Title of Change:	AR0522 Datasheet Update
Effective date:	03 Jul 2020
Contact information:	Contact your local ON Semiconductor Sales Office or Sonya.Yip@onsemi.com
Type of notification:	This Product Bulletin is for notification purposes only. ON Semiconductor will proceed with implementation of this change upon publication of this Product Bulletin.
Change Category:	Documentation Change
Change Sub-Category(s):	Datasheet/Product Doc change

AR0522 Datasheet Changes

Figure 3. Typical Configuration: Serial Four-Lane HISPI Interface

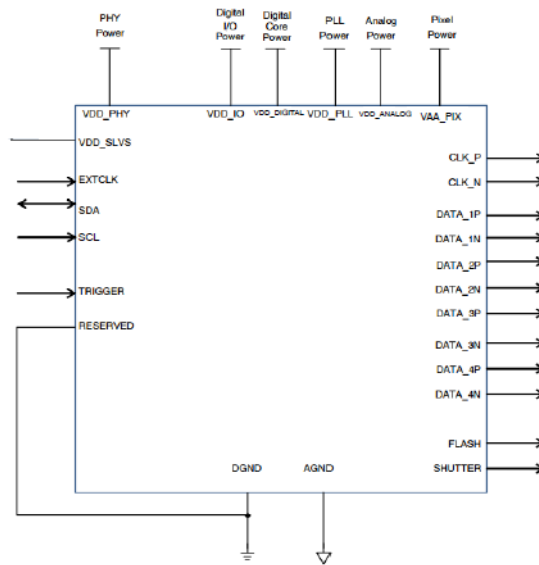
1. Updated Figure 3, “Typical Configuration: Serial Four-Lane HISPI Interface” Notes

1. If using an internal regulator, leave VDD_SLVS floating and set R0x31BC[13]=1 and R0x31BE[3:2]=0
2. If connecting DVDD_SLVS to 0.4V external power supply, set R0x31BC[13]=0 and R0x31BE[3:2]=1
